UNITED STATES PATENT AND TRADEMARK OFFICE

APPLICATION NO.	FILING DATE	FIRST NAMED INVENTOR	ATTORNEY DOCKET NO.	CONFIRMATION NO.
10/570,821	03/06/2006	Klaus Becker-Weimann	42660119PUS1	7091
2292 7590 07/25/2008 BIRCH STEWART KOLASCH & BIRCH PO BOX 747 FALLS CHURCH, VA 22040-0747			EXAMINER HAGEDORN, MICHAEL E	
			ART UNIT 4159	PAPER NUMBER
			NOTIFICATION DATE 07/25/2008	DELIVERY MODE ELECTRONIC

Office Action Summary	Application No. 10/570,821	Applicant(s) BECKER-WEIMANN, KLAUS	
	Examiner MICHAEL HAGEDORN	Art Unit 4159

DETAILED ACTION

Figure 1

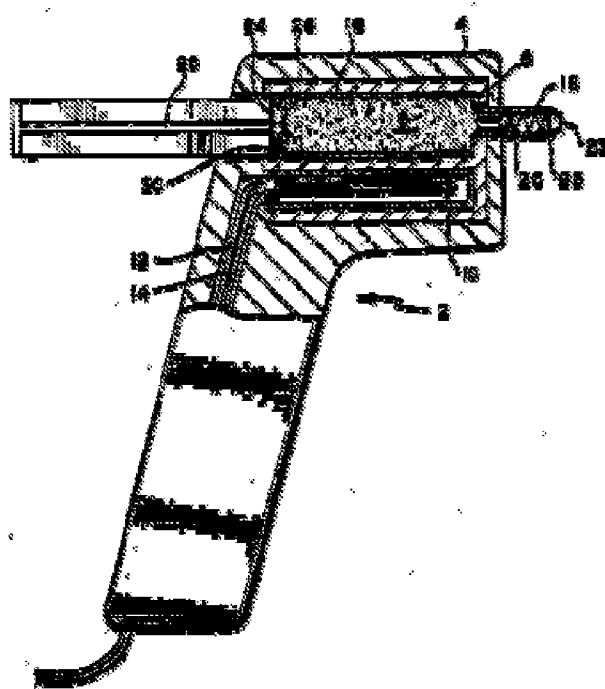
9. In Re claim 10, with reference to figure 1, and the speciation, Belanger et al (US Patent 5,026,187) discloses

a. An adhesive fluid dispensing device (2) with an adhesive fluid dispensing tip (18) to which a flow from an adhesive fluid cartridge passes (6), and a manually actable adhesive fluid cartridge actuating ram (28), the adhesive fluid cartridge being assigned a heating cartridge (10) for heating the adhesive fluid

(8) to a temperature sufficient for flow to pass through an adhesive fluid dispensing tip (18) upon actuation of a ram, wherein the heating cartridge (8) is not in direct contact with the adhesive fluid dispensing tip (18), and the dispensing tip is composed of readily heat-conductive material (column 4, lines 32-35).

10. In Re claim 11, with reference to figure 1 below, Belanger et al. (US Patent 5,026,187) discloses

a. An adhesive fluid dispensing device (2), wherein the dispensing tip (18) is heated substantially just by the adhesive fluid flowing out.

11. In Re claim 12, with reference to figure 1, and the speciation, Belanger et al (US Patent 5,026,187) discloses

a. The adhesive fluid dispensing device (2), wherein the dispensing tip (18) is heated substantially just by the adhesive fluid (8) flowing out.

12. In Re claim 15, with reference to figure 1, and the speciation, Belanger et al (US Patent 5,026,187) discloses

a. The adhesive fluid dispensing device (2), wherein the ram (28) acts on the plunger (24).

13. In Re claim 21, with reference to figure 1, Belanger et al (US Patent 5,026,187) discloses

a. An adhesive fluid dispensing device (2), wherein power is supplied by electric current (14).

Figure 2

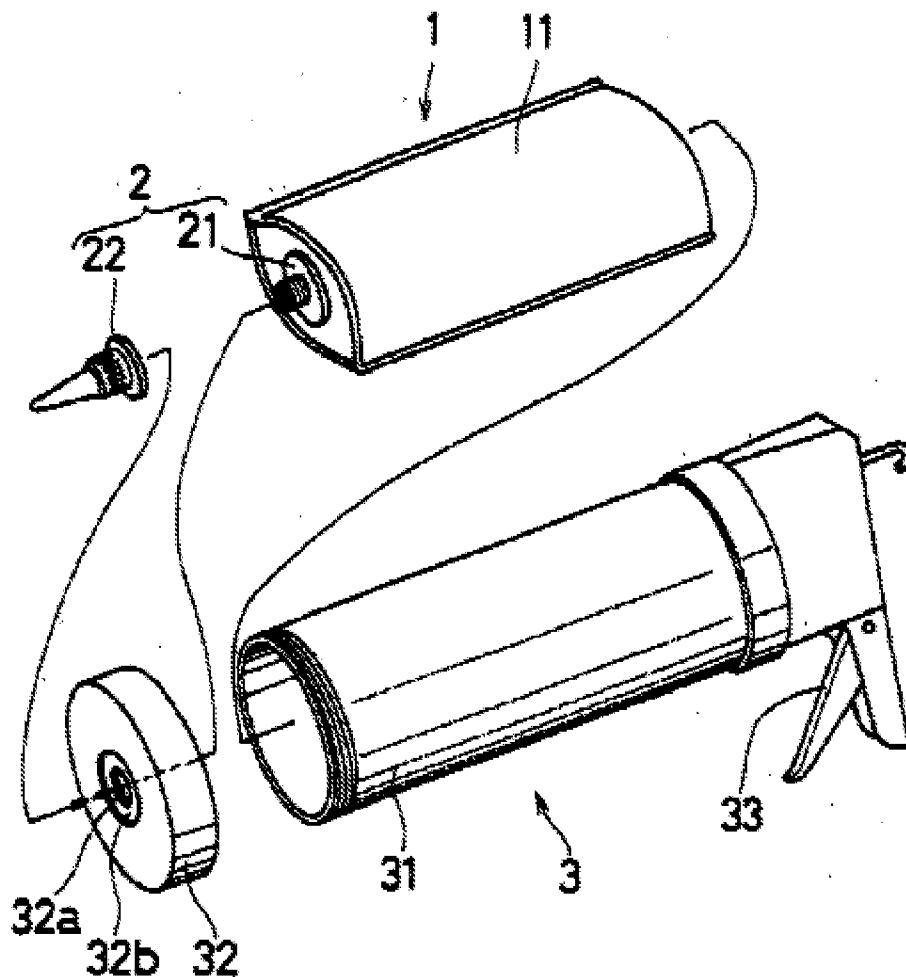
17. In Re claim 13 and 14, Belanger et al. has been discussed above, but doesn't disclose an adhesive fluid dispensing device, wherein the adhesive fluid cartridge is composed of metal and onto a metal thread on the dispensing device. However Miyata et al, with reference to figure 2 below, discloses an adhesive fluid dispensing device (3), wherein the adhesive fluid cartridge (1) is composed of metal and onto a metal thread (21) on the dispensing device. It would have been obvious to one of ordinary skill in the art to implement Miyata's teaching into Belanger's invention because this would allow the container to be emptied, cleaned and easily disposed of.

Figure 3

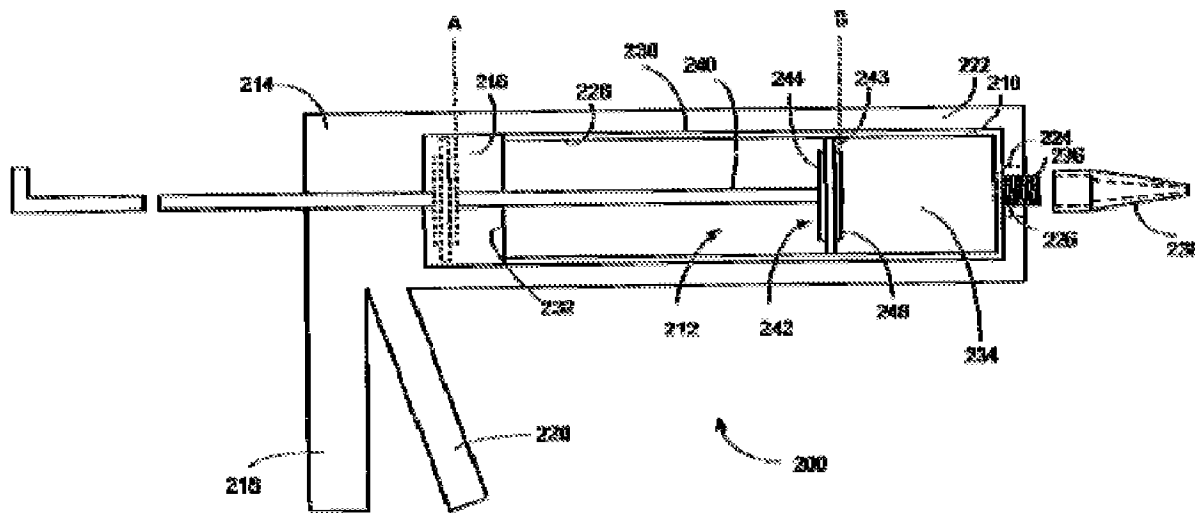
19. In Re claim 16 and 17 Belanger et al. has been discussed above, but doesn't disclose an adhesive fluid dispensing device, wherein the ram is assigned a pistol-type and pliers-type handle. With reference to figure 3 below, Osborn et al. discloses a pistol-

type and pliers-type handle (220). It would have been obvious to one of ordinary skill in the art to implement a pistol-type or pliers-type handle because this will provide the user better control when dispensing the contained fluid as well as comfort and less force needed to drive the ram.

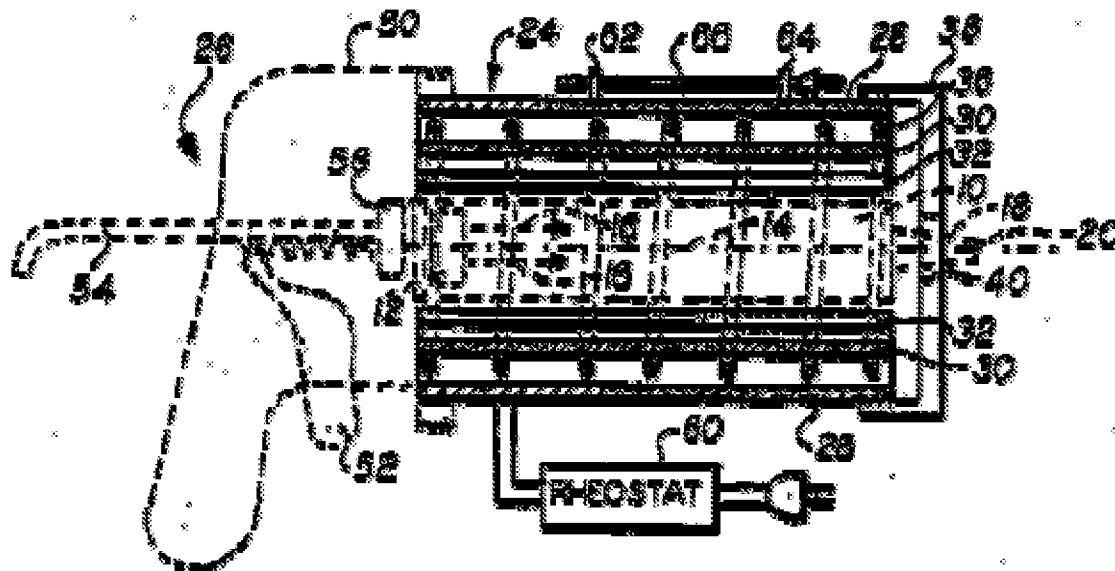
21. In Re claim 18 Belanger et al has been discussed above, but doesn't disclose an adhesive fluid dispensing device, wherein the heating cartridge is arranged around the cartridge. With reference to figure 4 below, Feldman does disclose a heating cartridge (10) that is arranged around the cartridge. It would have been obvious to one of ordinary skill in the art to implement a heating cartridge that is arranged around the cartridge because this would insulate the fluid prevent initial clogging of the adhesive through the

extrusion nozzle. Furthermore, by arranging the heating cartridge around the adhesive cartridge less time would be needed to melt the adhesive reducing waiting time

22. In Re claim 19, Feldman teaches an adhesive fluid dispensing device, wherein the heating of the cartridge content takes place from diametrically opposite sides as shown in figure 4 (shown below).
